RE: Pawling Commons
Amended Site Plan
63, 67 and 71 East Main Street

Enclosed please find responses to comments included in the 1/04/24 planning review memorandum prepared by Caren LoBrutto of LaBella. Our responses, in boldface, are keyed to the referenced review memorandum.

AMENDED SITE PLAN FOR ALTERNATE EXPANSION

SY-1

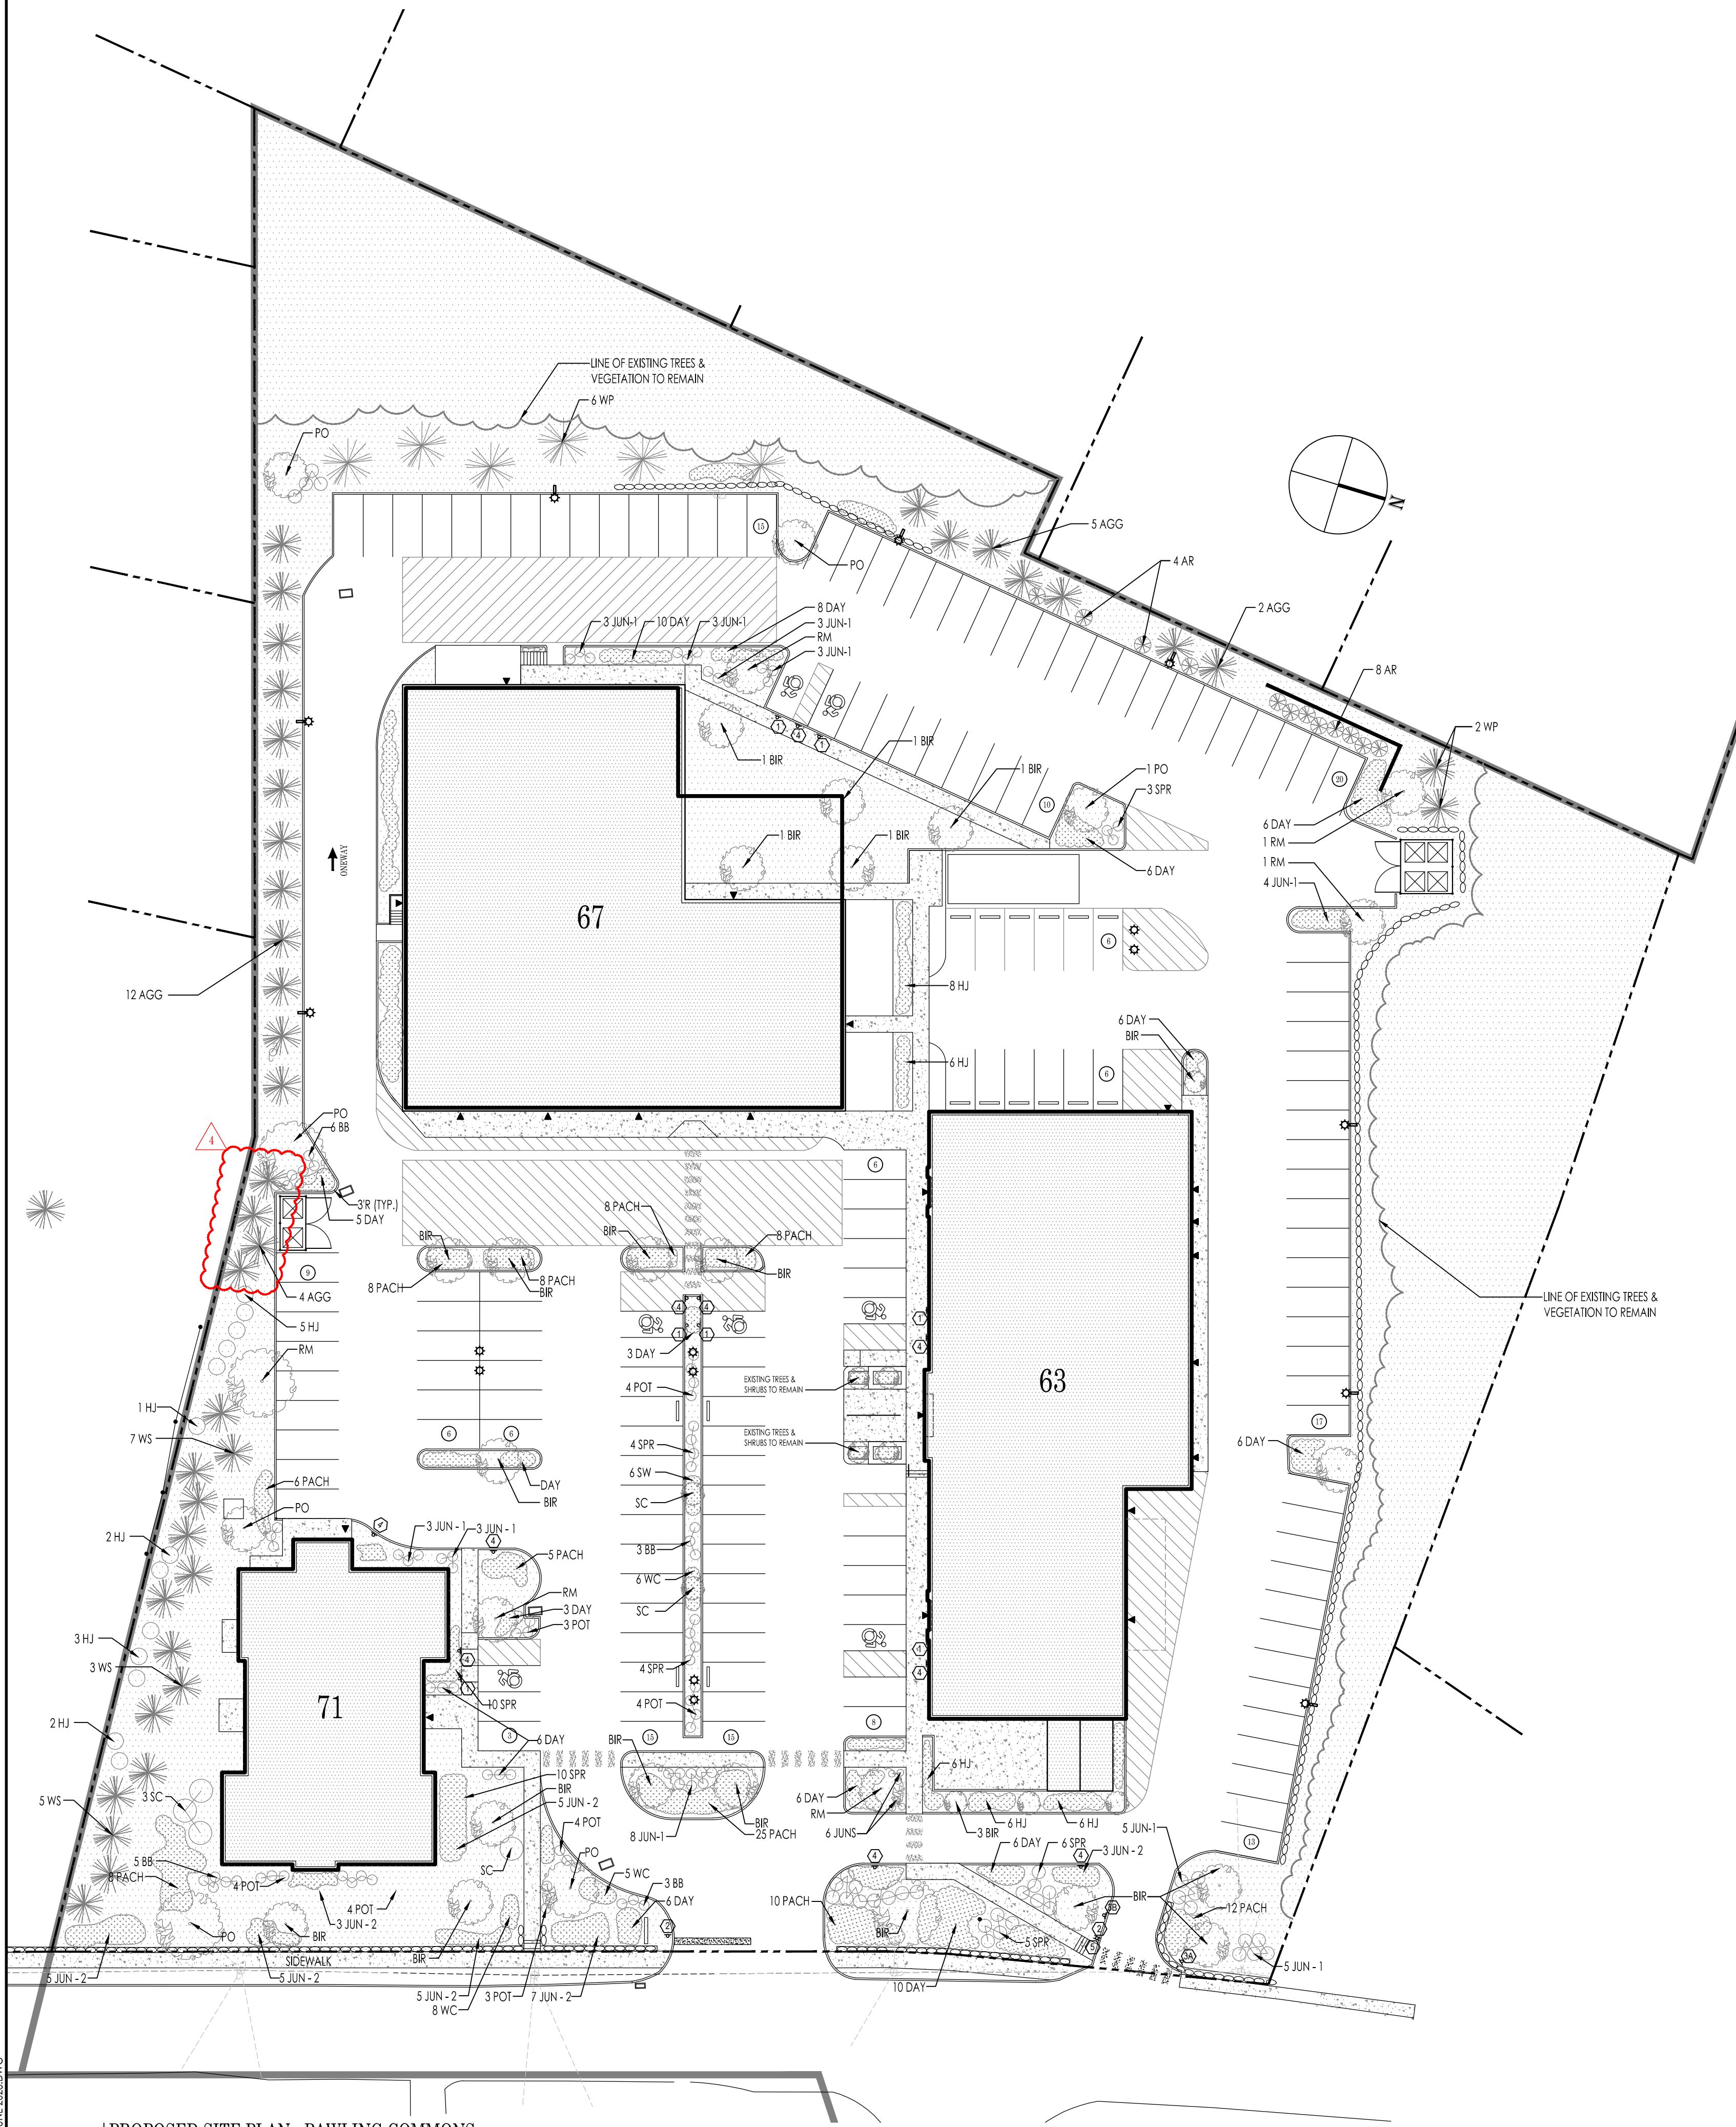
4. The USFWS indicates the potential for regulated bat species at this location. Therefore, tree clearing restrictions should be implemented and a note should be added to the plan.

Response: the note regarding the tree-clearing prohibition between April 1 and October 31 has been added to the plan.

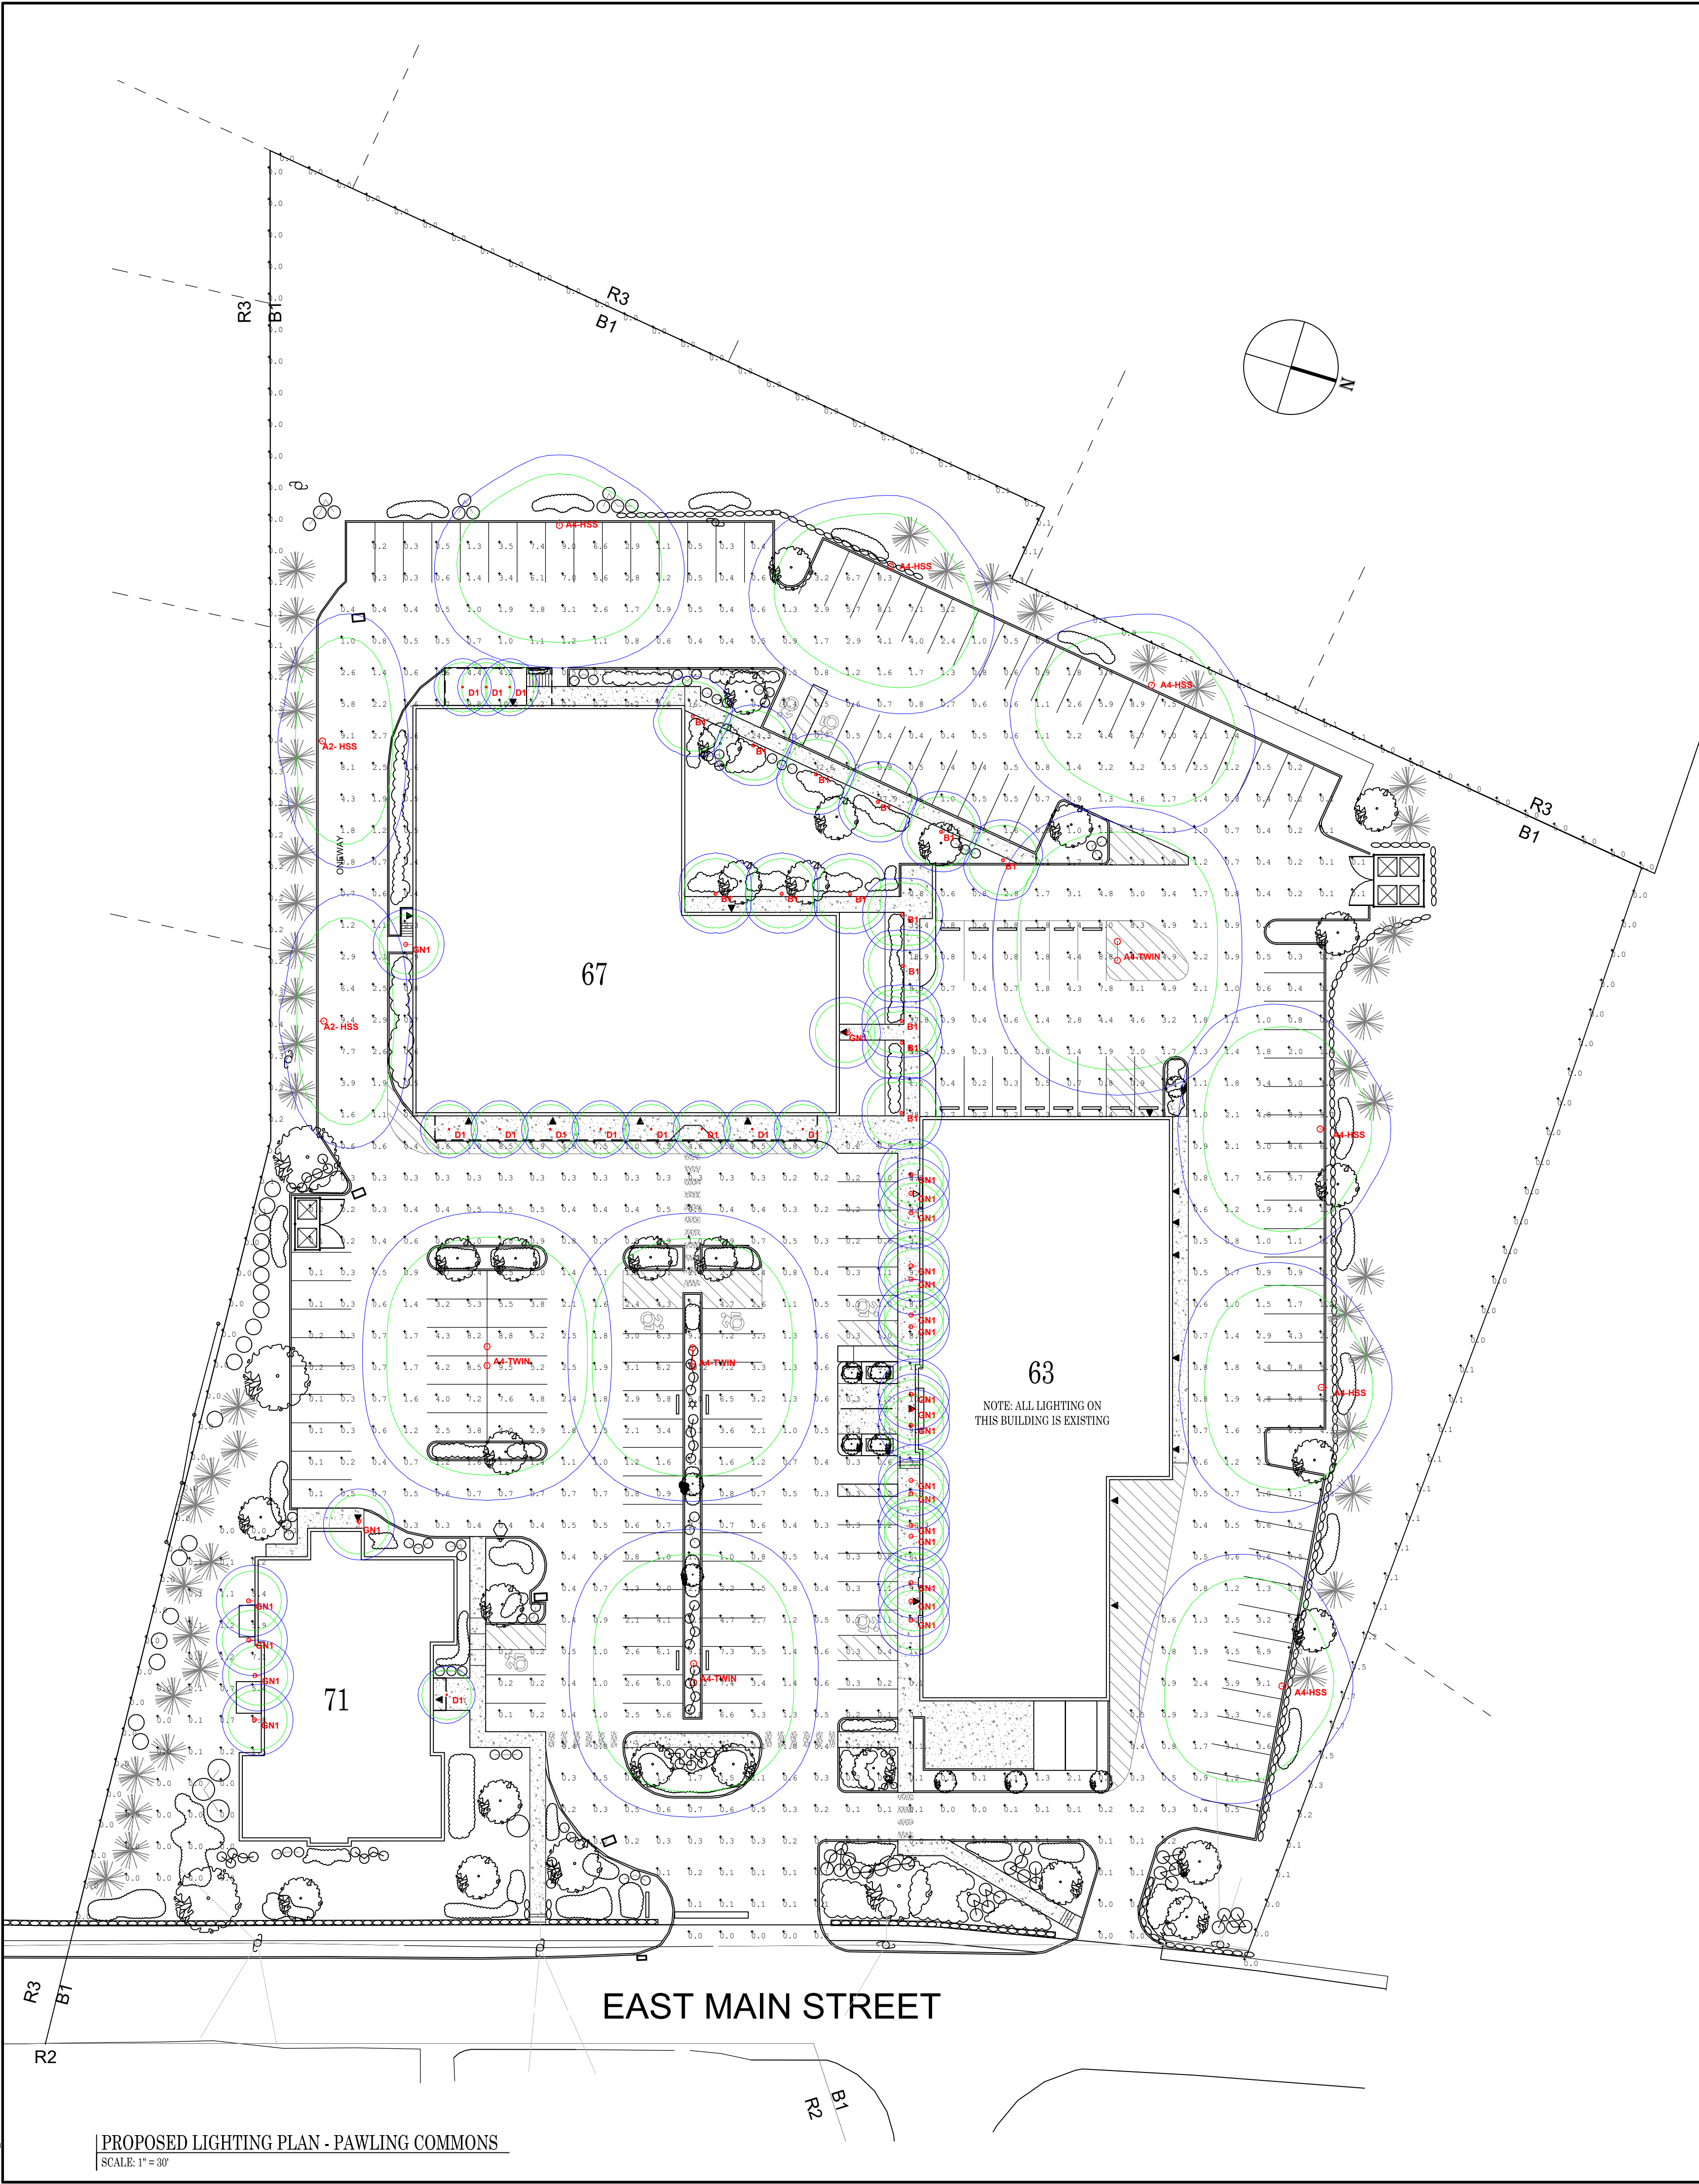
6. Burning bush and winter creeper are both considered invasive by NYSDEC. Please provide alternatives.

Response: the landscape plan has been revised to provide non-invasive alternatives to these referenced plants.
